Item 3.**Development Application: 17 Billyard Avenue, Elizabeth Bay - D/2021/1261**

File No.: D/2021/1261

Summary

Figure 43: Plan area calculation sheet extract depicting boarding room 04, with the excessive kitchen size circled in red

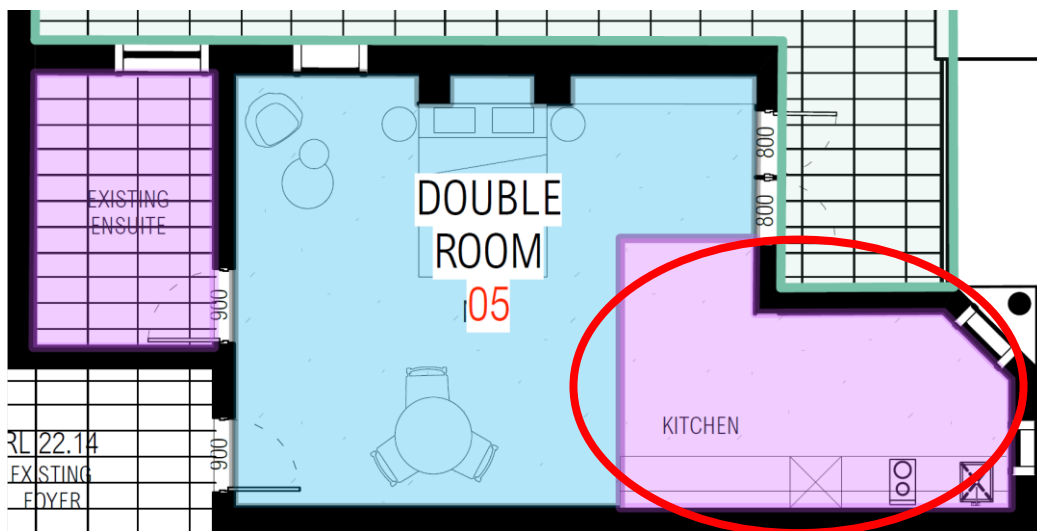
95. The areas identified in the application documentation as kitchens in boarding rooms N04 and N05 is excessive, as depicted in the drawing extracts provided in the two figures provided below. The overall size of the boarding rooms (excluding the actual kitchen and bathroom areas) exceeds 25 square metres as a result.

96. Clause 30(1)(b) of the Affordable Rental Housing SEPP states that a consent authority must not consent to development to a boarding house unless it is satisfied that no boarding room will have a gross floor area (excluding any area used for the purposes of private kitchen or bathroom facilities) of more than 25 square metres.
97. A written request to vary the standard, made pursuant to Clause 4.6 of the Sydney LEP 2012, has not been submitted with the application.
98. The Local Planning Panel cannot grant consent to the proposed development in accordance with of Clause 4.6(3) of the Sydney LEP 2012 without a Clause 4.6 addressing this issue. This is unsatisfactory.

Figure 45: Perspective extract depicting the proximity of the cantilevered form of the new rear addition over the existing contributory building circled in red

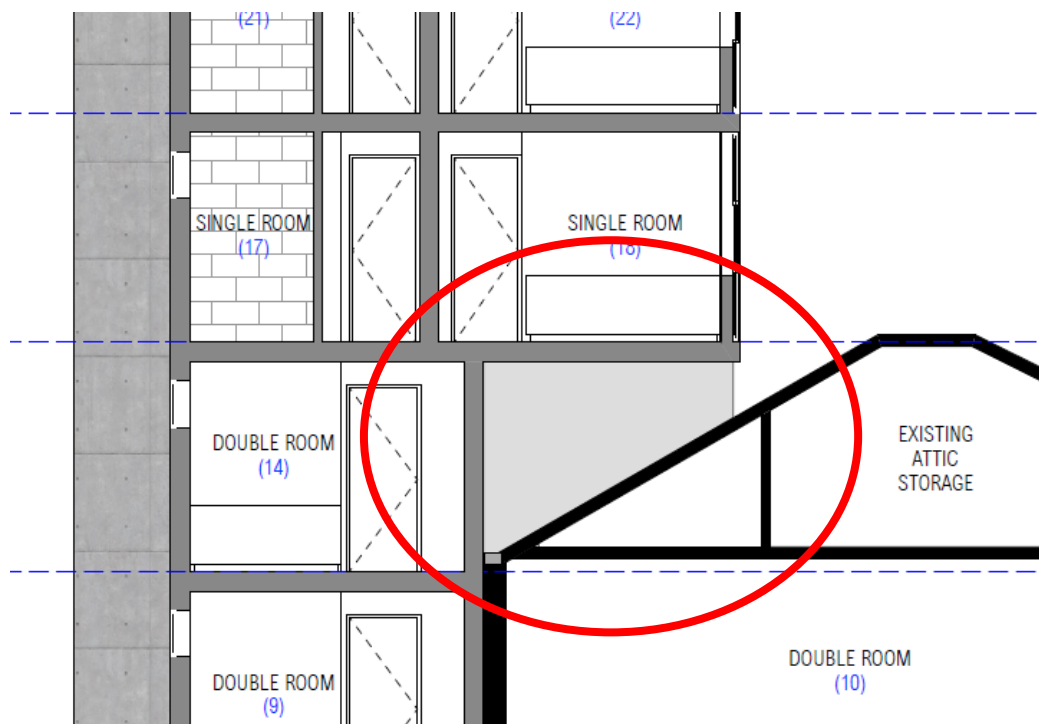
- (d) No geotechnical and structural information has been submitted with the application to address excavation impacts associated with the development on the adjacent contributory buildings and sandstone cliff face.

103. The effect of the proposed development on the heritage significance of the heritage conservation area is not supported as a result and is contrary to the objectives of Clause 5.10 of the Sydney LEP 2012 and Section 3.9 of the Sydney DCP 2012. This is unsatisfactory.

Figure 48: Aerial photograph of the subject site (shaded in blue), with primary view lines in red from adjacent properties numbered 1, 2 and 3

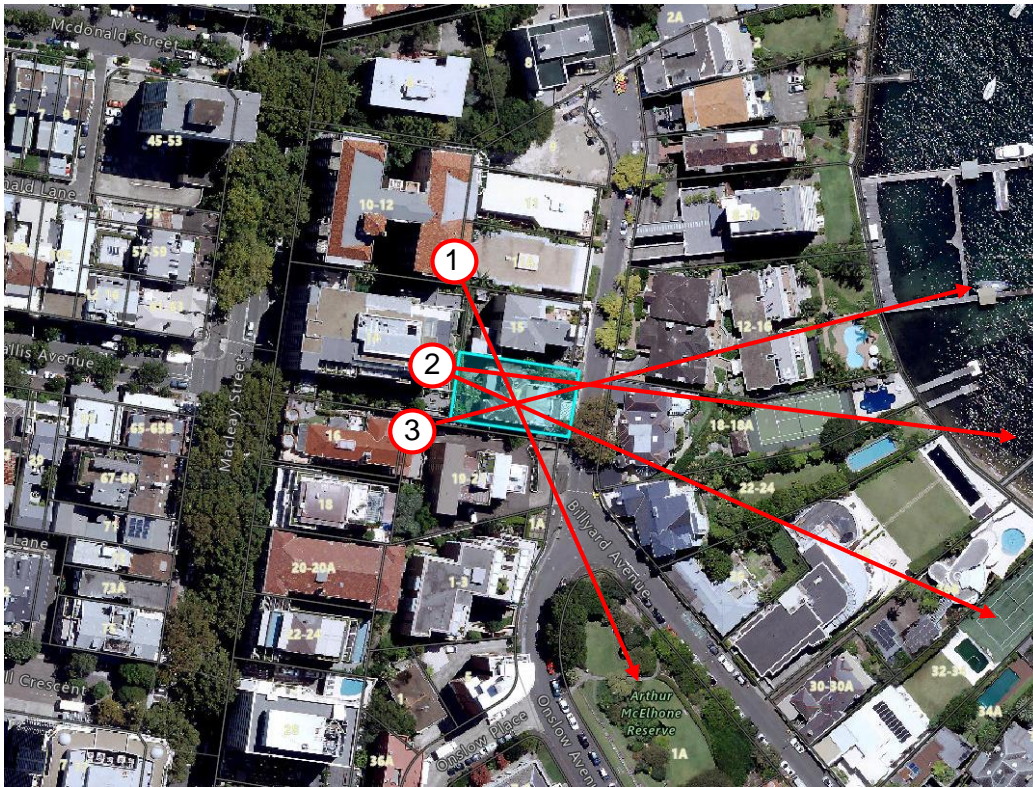
116. No view assessment has been submitted with the application made against the relevant planning principle established in *Tenacity Consulting v Warringah Council* [2004] NSWLEC 140.

Figure 50: Photograph from a standing position within the terrace of a ground level apartment in the south-eastern corner of the 'Pomeroy' building at 14 Macleay Street, Potts Point, looking east

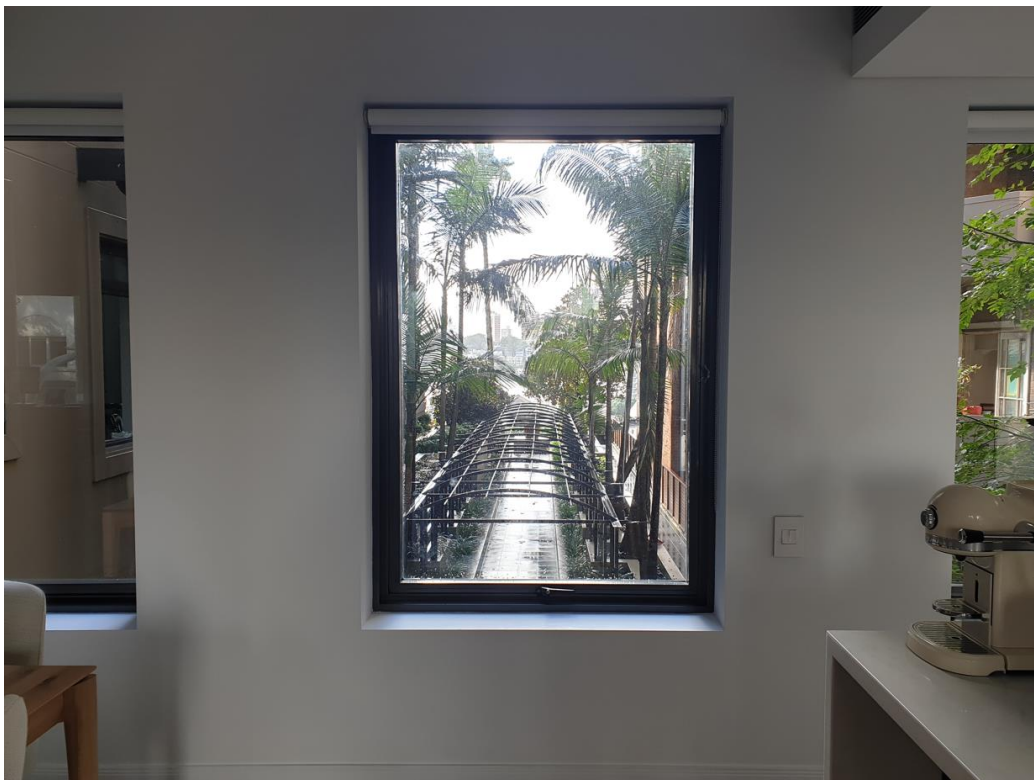
- (b) Severe to devastating, particularly for the apartments at the lower and ground floor levels in the south-eastern corner of the building.
132. The impacts on these existing views might be mitigated by a more skilful and compliant design and, as such, they are unreasonable in the circumstances.

Figure 58: Axonometric drawing extract of midwinter overshadowing to the 'Casa Del Sol' building at 19-21 Billyard Avenue, Elizabeth Bay

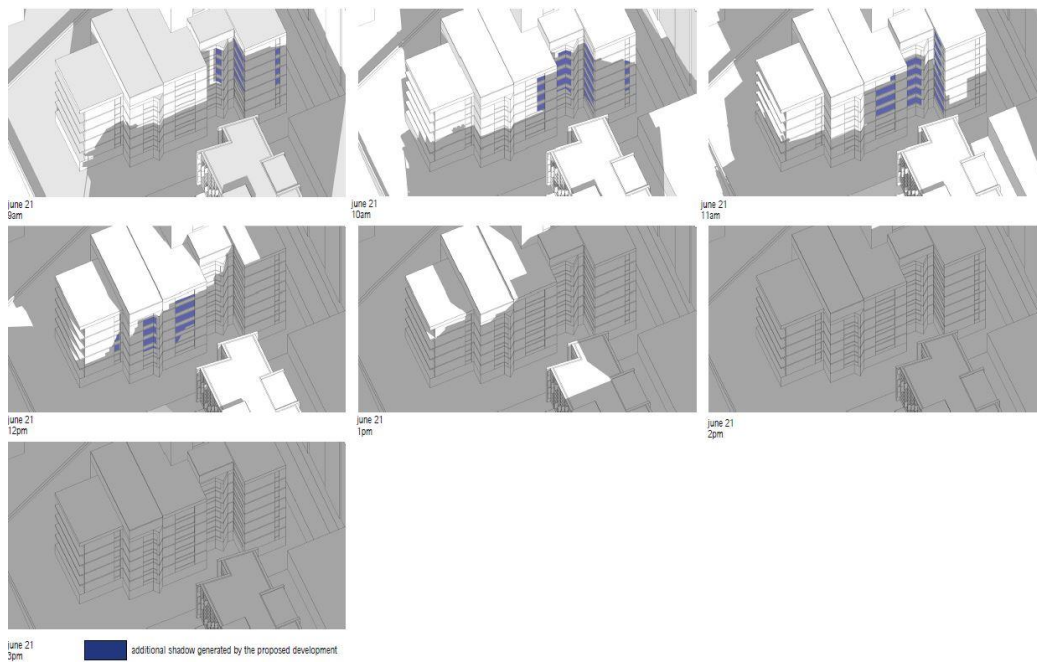
141. As discussed elsewhere in this report, the documentation submitted with the application relating to overshadowing of the adjoining properties is inadequate.
142. As depicted in the drawing extract reproduced in the figure provided below, the application has only provided axonometric diagrams of overshadowing at midwinter to the 'Casa Del Sol' building at 19-21 Billyard Avenue, Elizabeth Bay.

143. In particular, sun's eye view diagrams of the existing and proposed development and all of the surrounding development to the west, south-west and south of the site, drawn at 15 minute intervals between 9am and 3pm at the midwinter solstice, have not been provided to Council to enable proper assessment of overshadowing impacts to the adjoining residential properties.

Figure 59: Plan drawing extract of boarding room N15 at level 4 and the adjacent 'Clanricarde' building at 15 Billyard Avenue, Elizabeth Bay, with the subject window circled in red

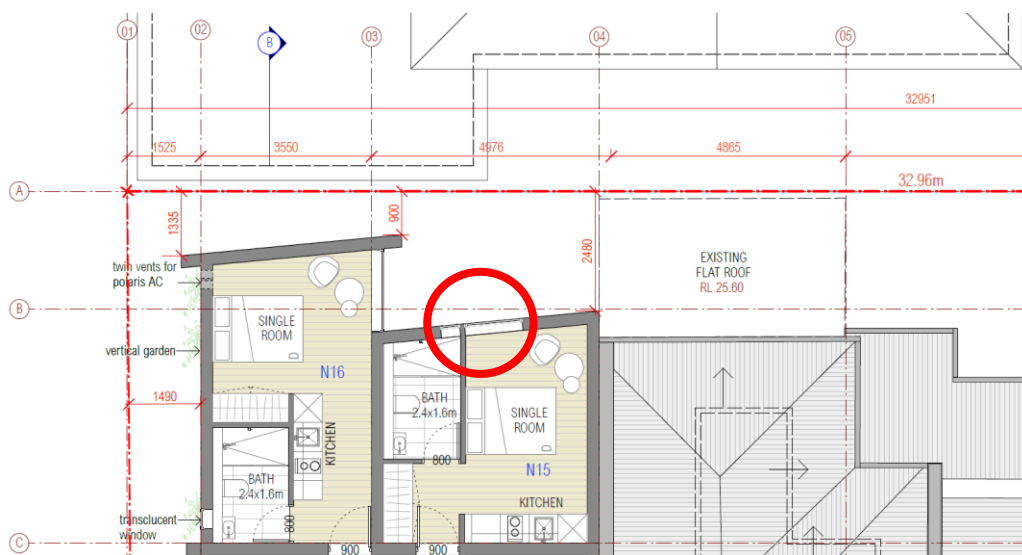
149. Furthermore, the acoustic report submitted with the application makes no assessment of noise generated by the boarding house use noise, including that generated from mechanical plant, or from use of the proposed external communal and private open spaces, particularly those which are in elevated positions within the site.

150. In the absence of detailed and comprehensive visual and acoustic privacy documentation and analysis addressing these matters, the application cannot be supported.

Figure 60: North elevation drawing extract, with the subject windows circled in red

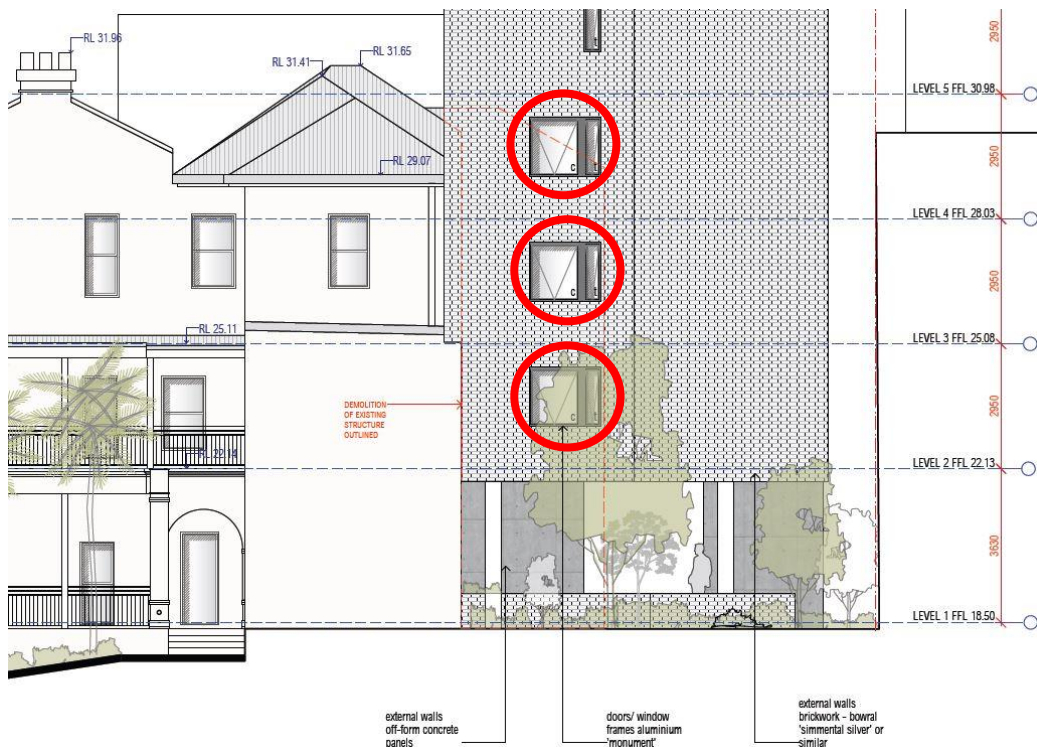
- The windows to the proposed boarding rooms N07, N12 and N15 are located in close proximity (less than 2 metres) to east-facing windows proposed to boarding rooms N08, N13 and N16, which results in poor acoustic privacy amenity, given that the windows are the main source of natural light and ventilation to the subject dwellings.
- The submitted acoustic report makes no assessment of noise generated by the boarding house use noise, including that generated from mechanical plant, or from use of the proposed external communal and private open spaces.
